From: [Raezer, Connie](#)
To: [Young, Betty \(UTC\)](#)
Cc: [Lockwood, Scott \(ATG\); "Stephen.Semenick@BNSF.com"](#)
Subject: Petition for 104520Y Resubmittal
Date: Friday, April 6, 2018 3:57:44 PM
Attachments: [SR 223 Crossing Concept WSDOT Prepared with BNSF edits.pdf](#)
[104520Y SR 223 Diagnostic Review Sheet Final.pdf](#)
[104520Y SR 223 Petition April 2018.pdf](#)

Washington State Dept. of Transportation)	DOCKET NO. TR-
_____)	
Petitioner,)	PETITION TO MODIFY HIGHWAY-
)	RAIL GRADE CROSSING ACTIVE
)	WARNING DEVICES
vs.)	
BNSF Railway Company)	
_____)	
Respondent)	USDOT #104520Y
)	
.....)	
)	
)

WSDOT RAILROAD GRADE CROSSING DIAGNOSTIC TEAM REVIEW WORKSHEET*

Section 130 Diagnostic Evaluation Meeting Summary SR 223, USDOT 104520Y

TYPICAL SECTION A-A

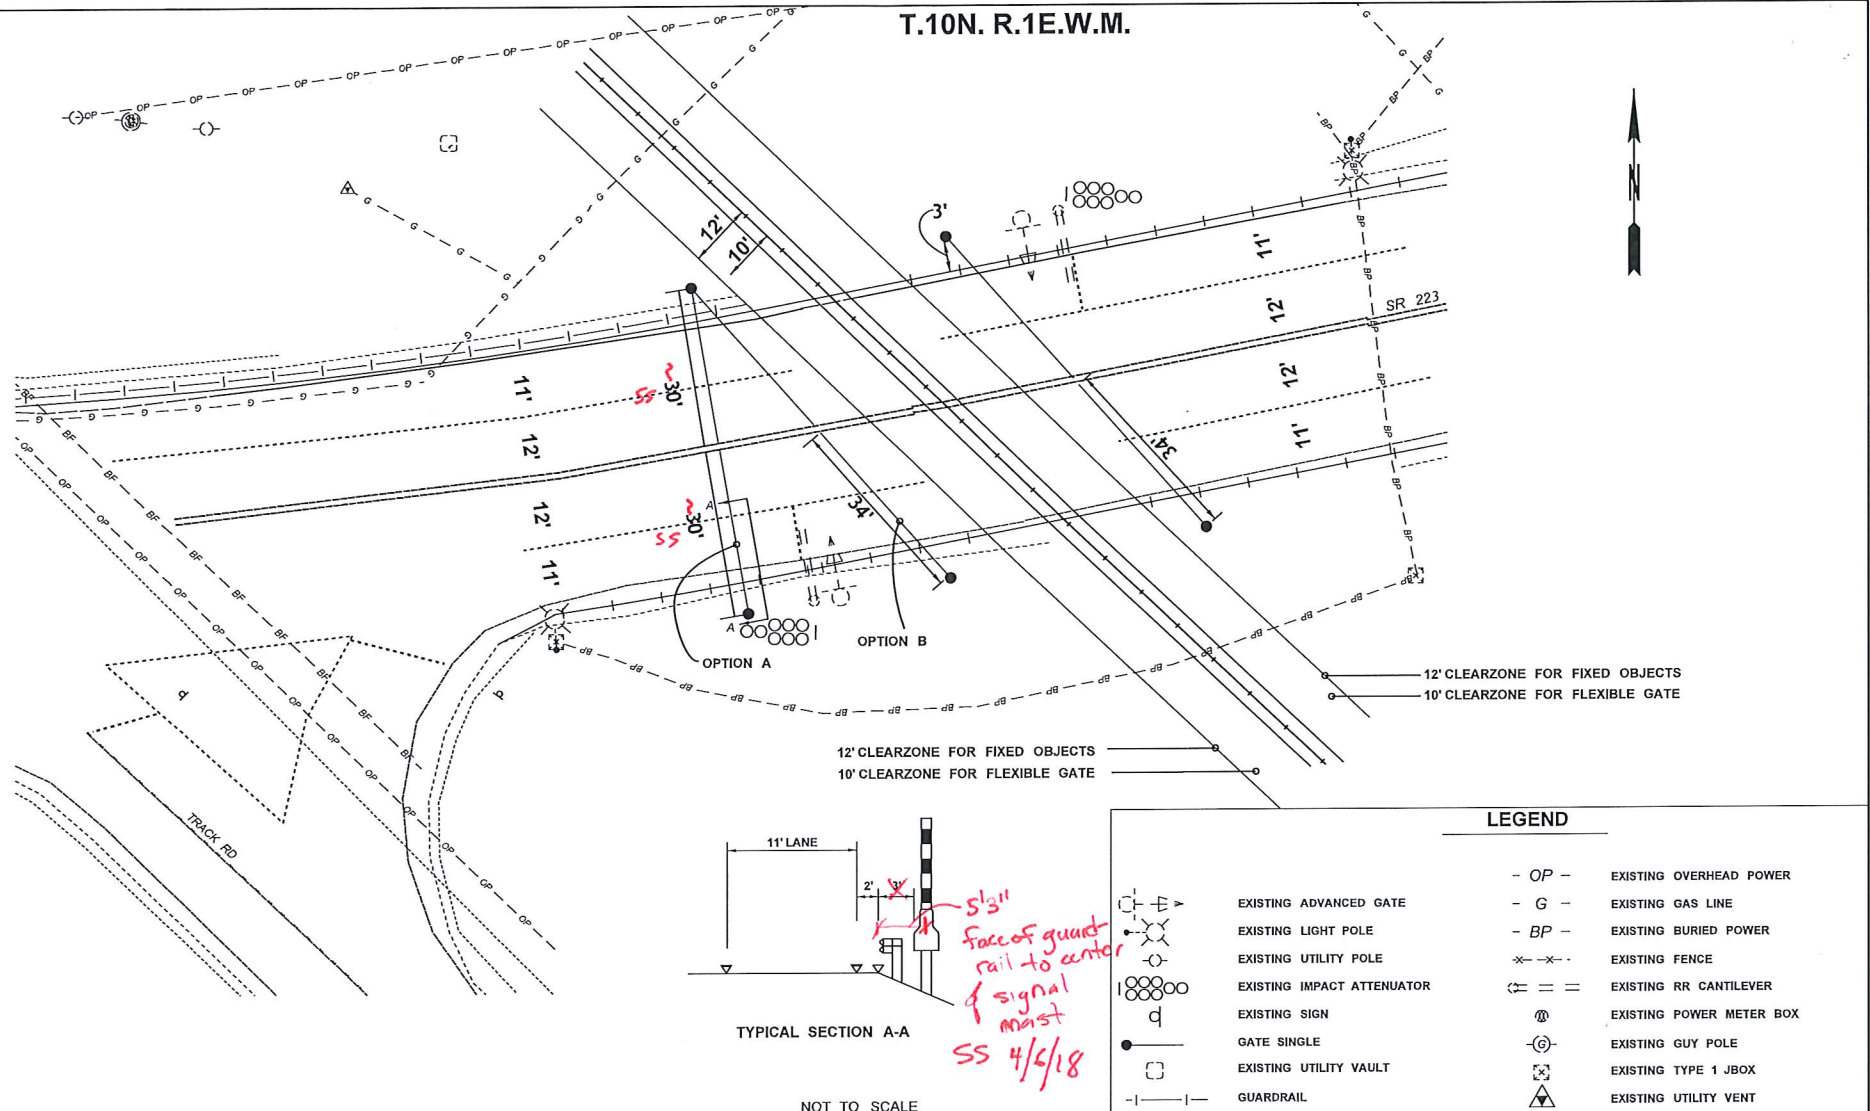
Please see the attached petition with waiver signed by BNSF. The petition and diagnostic team worksheet were updated to remove constant warning time reference as this is already active at the crossing. WSDOT prepared the concept that is attached and would like to add this a supplementary information to the petition, BNSF has reviewed and made edit(s). This concept will guide each party as to design. BNSF will make final determination of placement of bungalow and signal infrastructure.
